CITY OF LAS VEGAS		DATE:
INTER-OFFICE MEMORANDUM		March 19, 2019
TO: Land Development Services Department of Building & Safety		FROM: Albert Sung, P.E. Flood Control Project Engineer Department of Public Works
SUBJECT:	Drainage Study for:	
	Summerlin West V22 – Kettle Ridge Drive (Street J) and Scurry Bend Drive (Street N) Street Improvements (both from Lake Mead Blvd. to Fleet Wing Ave.)	
Cross Streets:	Lake Mead Boulevard & Desert Foothill Drive	Howard Hughes Company, LLC
File Number:	F:\Depot\DSMemos\DS5156E.doc	Bart Anderson, P.E., DevCo
Parcel Number:	137-14-401-006 & 137-23-101-002	CCRFCD
Zoning Action:	N/A	
FEMA Flood Zone	YES	NO X
Proposed Storm Drain	YES X	NO

From: Anderson, Molly <Molly.Anderson@atkinsglobal.com>
Sent: Thursday, March 12, 2020 2:05 PM
To: Albert Sung
Subject: Kettle Ridge Drive Update #1 supplemental information
Attachments: Comment 1.pdf; Comment 2.pdf; Comment 3.pdf

DS 5156-1
K-14

Summerlin Village 22: Kettle Ridge Drive (Fleet Wing to Lake Mead)

1078097
CLV L19-02315
DATE: MARCH, 2020
DRAWING NO. 18/43

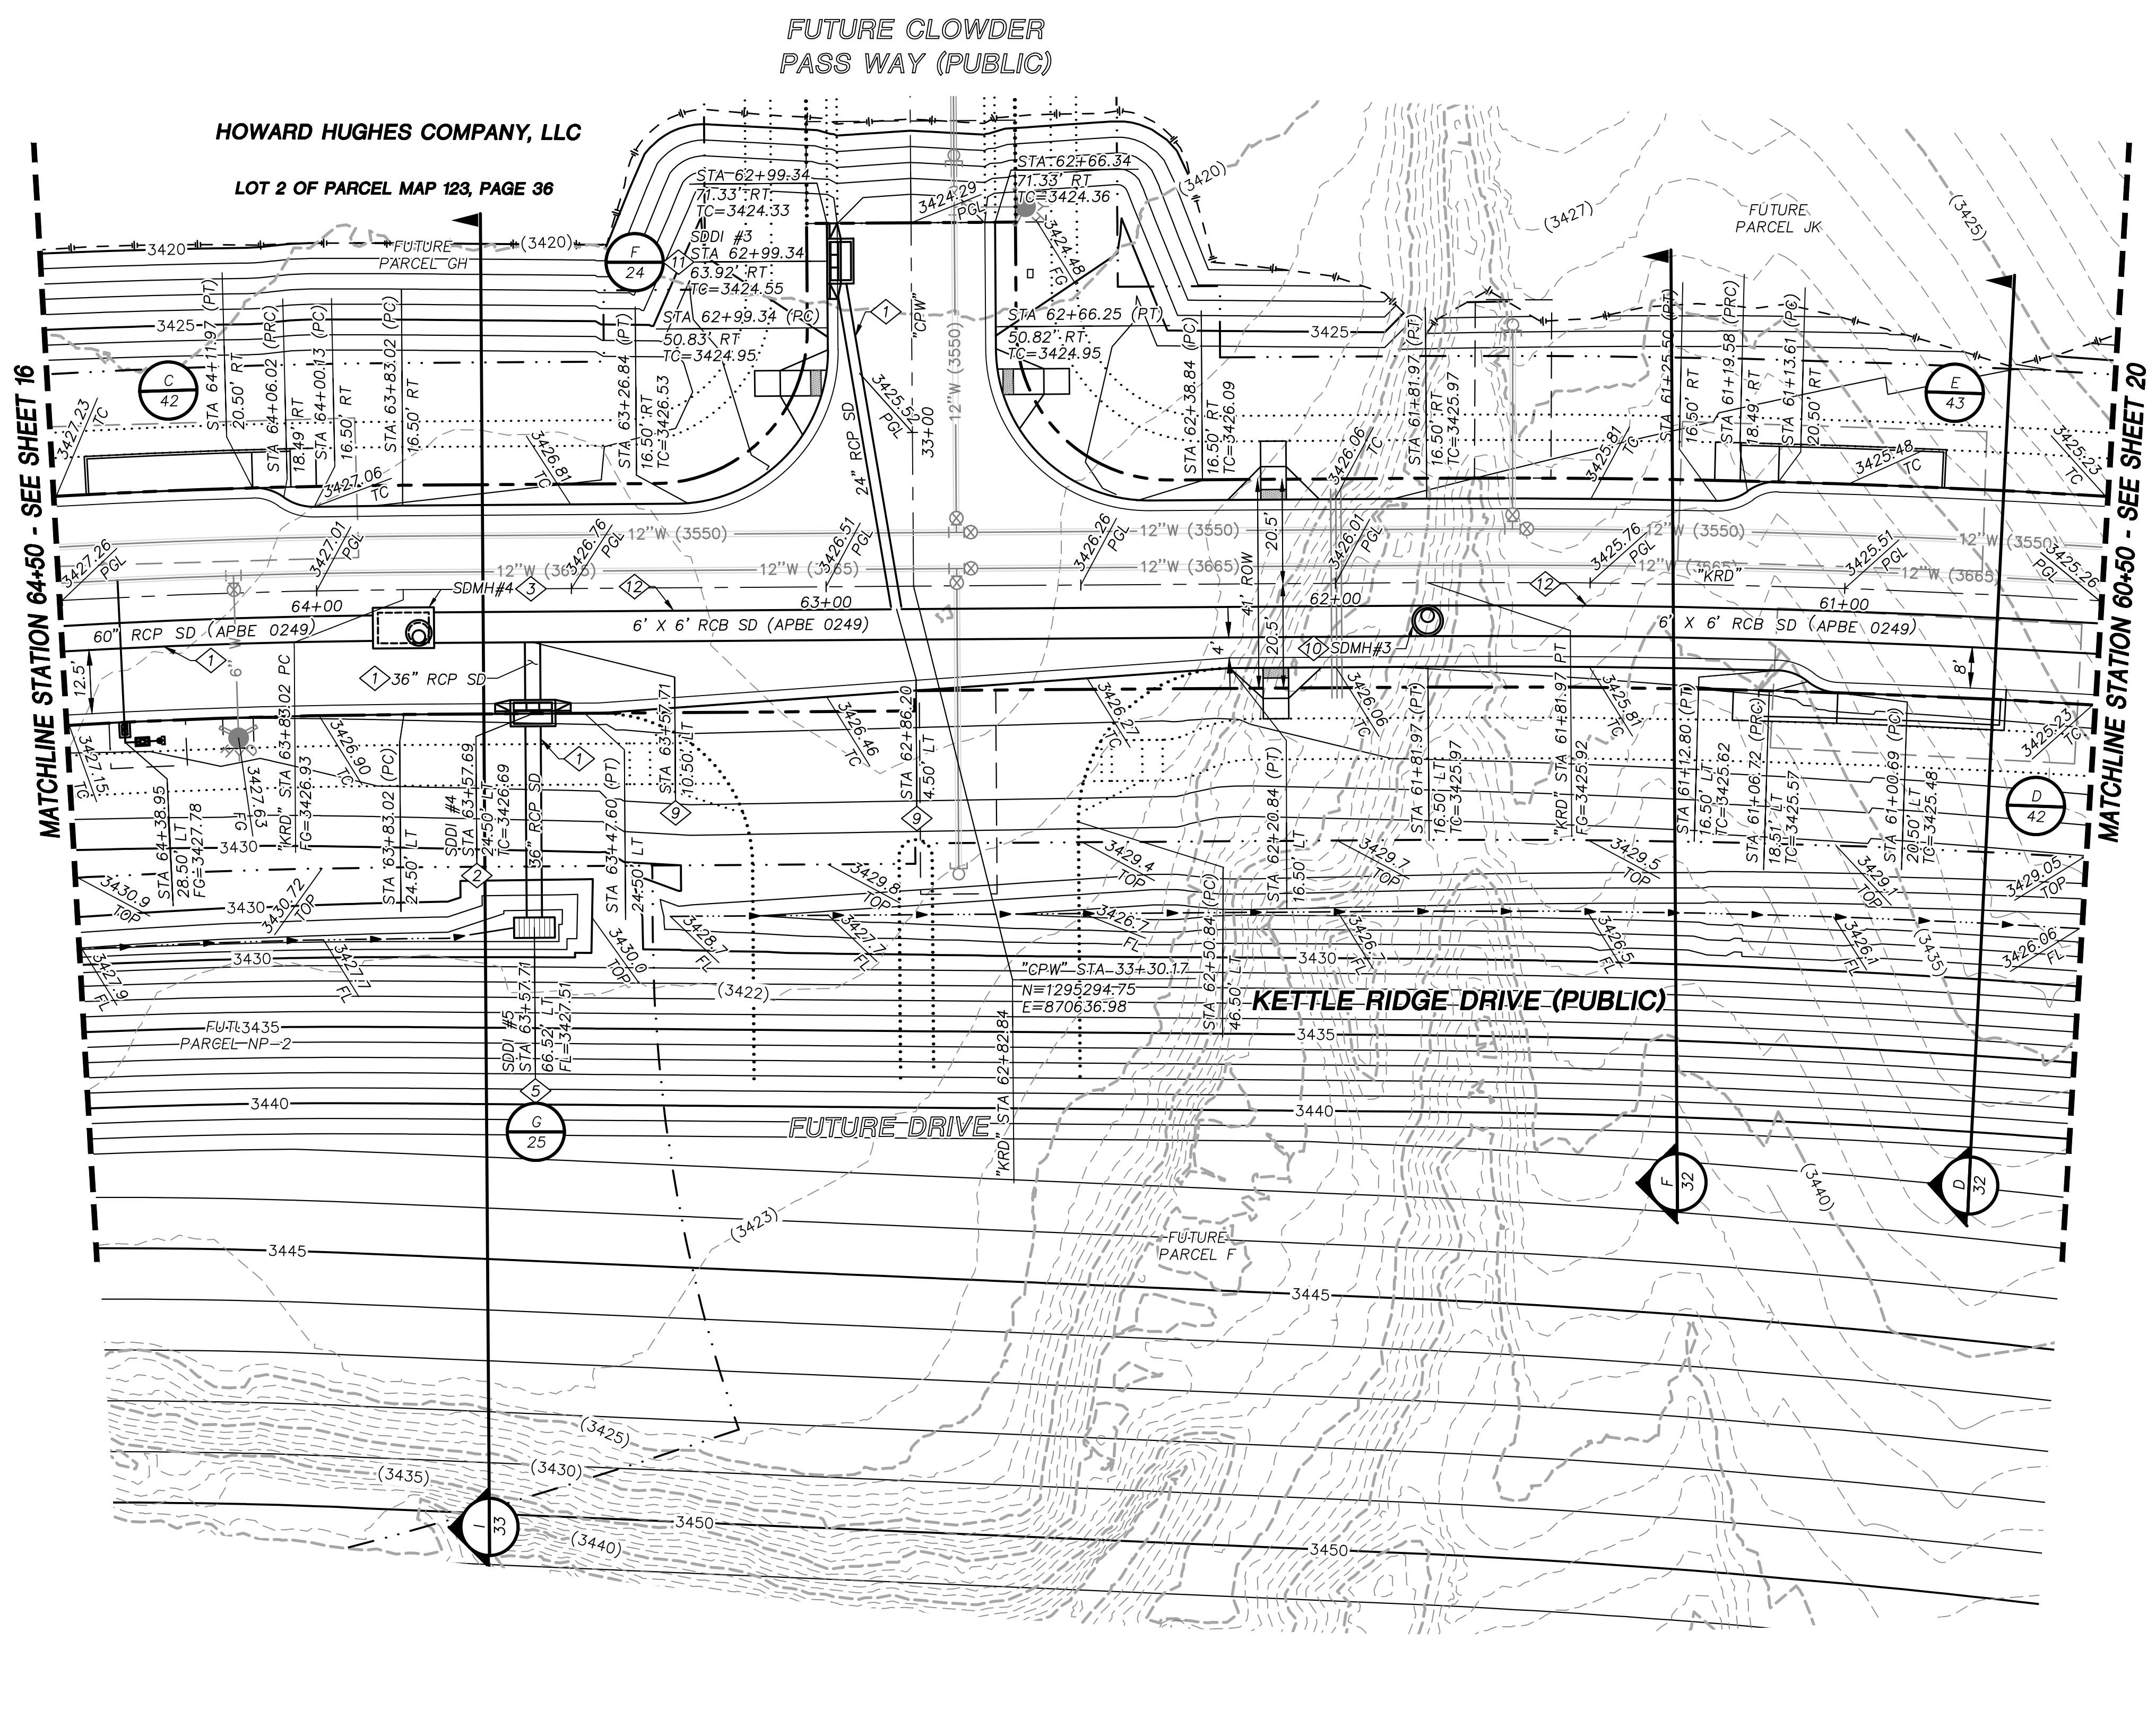
Comment #1: From the *Sheet 18/39* to *Sheet 21/39*, there are various proposed direct connection of lateral pipes to the 6'x6' RCB. However, the connection detail has not been provided. Provide as such in the next submittal.

The response on *Storm Drain Construction Note #9* refers the connection detail to Sheet 33 should be revised to Sheet 34.

Comment response: The connection detail callouts have been revised. A sheet had been added to the plans between submittals, making the new sheet #35, which was not included in the Update #1 submittal. Please see the pdf attached titled "Comment 1".
